**4. Zoning By-Law Amendment – 25 Grant Street**

**File Number: ACS2020-PIE-PS-0033**

**SUBJECT: Zoning By-law Amendment – 25 Grant Street**

25 Grant Street

Elevations - West Side Elevation

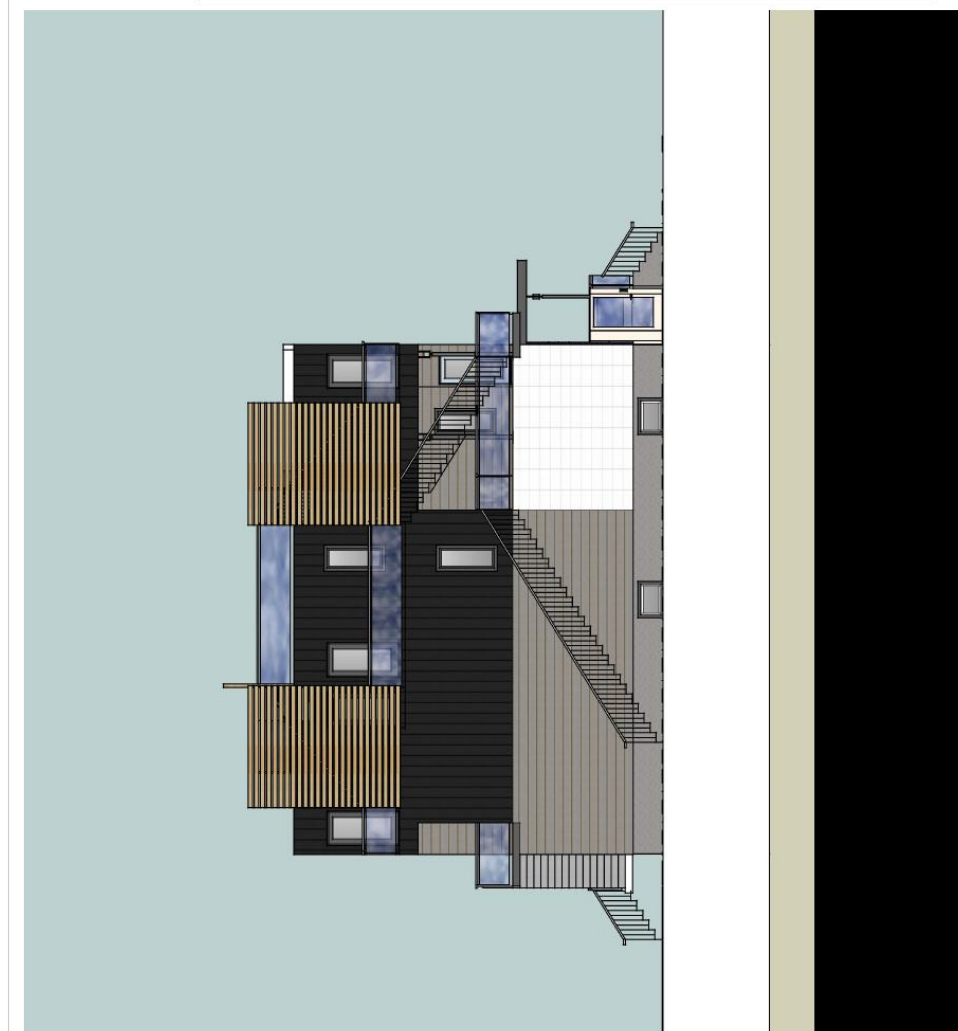
**Comment:** The stairs in the western side yard are very intrusive.

The fact that exterior stairs are used to provide the secondary exits required by the fire code indicates that there are too many units. It would be preferable to provide the secondary exit stairs inside the building envelope. If this is not possible, the stairs should be enclosed, and the building shifted to the east by reducing the driveway width.

Access to the roof-top patios should be provided inside the units.

**Comment:** We are opposed to the reduction of the set back for the western roof top fire stair and access.

The interior side yard stair and rooftop access has had screening added to minimize some overlook. The potential for overlook is also minimized by the private nature to the interior side yard stairs, rather than being for public access for all residents.
